M^CLAREN TRAFFIC ENGINEERING

23 March 2020

Reference: 190701.03FA

TRAFFIC RESPONSE TO FAIRFIELD CITY COUNCIL FOR THE PROPOSED SAINTS PETER AND PAUL ASSYRIAN PRIMARY SCHOOL AT 17 - 19 KOSOVICH PLACE, CECIL PARK, 2178

FIGURE 2: EXISTING INTERSECTION LAYOUT

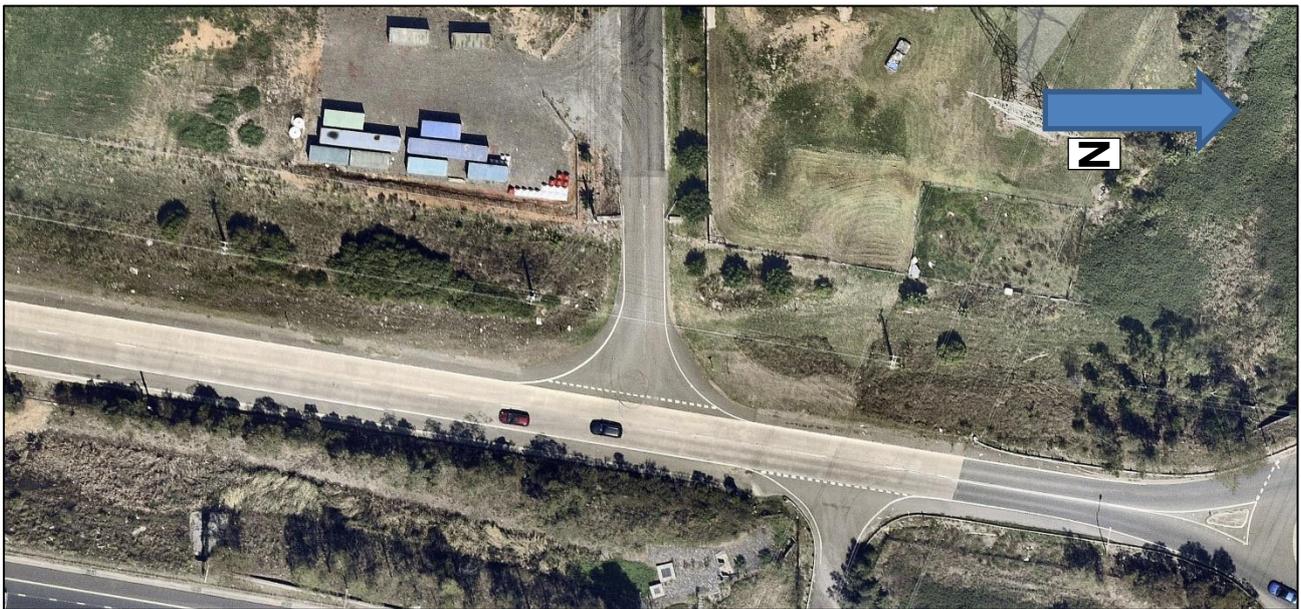
The proposed auxiliary right-turn lane on Wallgrove Road into Kosovich Place and 'No Right Turn' restriction from Kosovich Place into Wallgrove Road is considered a safety hazard for motorists at the intersection and to school children. RMS recommend that a roundabout be proposed at the intersection to improve the safety of turning traffic at Kosovich Place/ Wallgrove Road; it will also benefit the safety of the road network by reducing the approach speed by motorists.

For the purposes of illustration, the existing intersection treatment is depicted in **Figure 2** and the proposed in **Figure 3**. The proposed changes will significantly improve the safety of the intersection by:

- Restricting right turns from Kosovich Place into Wallgrove Road, which is presently an unsafe movement during peak times;

- Addition of deceleration facilities for the left turn into Kosovich Place from Wallgrove Road, significantly reducing or eliminating the existing risk of rear-end collisions involving vehicles making this turn;
- Addition of storage facilities for the right turn into Kosovich Place from Wallgrove Road, significantly reducing the existing risk of rear-end collisions and side-on collisions involving vehicles making this turn.

In view of the above, it is incorrect to assert that the proposal will detrimentally impact the traffic safety at the Kosovich Place/Wallgrove Road intersection, as the intersection will be significantly safer post-upgrade. Any negative traffic safety implications related to the additional school traffic are outweighed by the significant upgrade works proposed.

Figure 1 – Primary schools within a 4km radius of 17-19 Kosovich Place, Cecil Park (Google Maps)

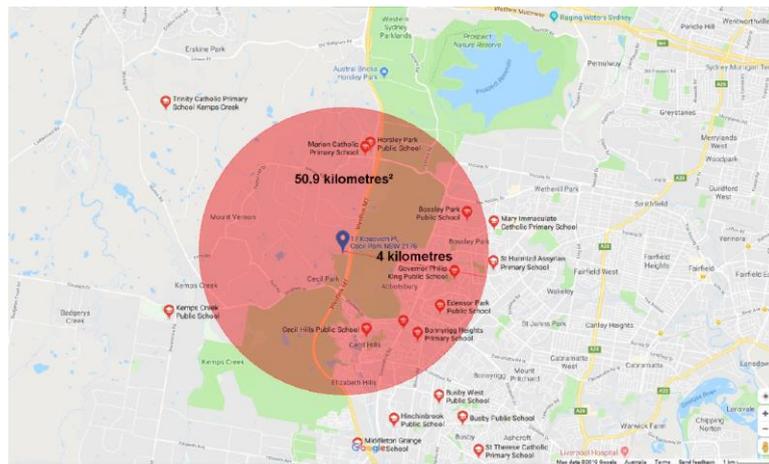
It is understood that the proposed primary school is associated with the adjoining Church and will deliver new educational facilities to meet the demand in Western Sydney. The 2016 ABS Census states reveal that the total population density in Cecil Park is 848 residents. In addition, the total population of primary students aged from 5-11 years in the Cecil Park is 61 ([Community Profile ID](#)). Furthermore, a search of primary schools within a 4km radius of the subject site reveal 8 primary schools within the Cecil Park area as shown in Figure 1 below. This provides an indication of the demand of primary schools within the area is low.
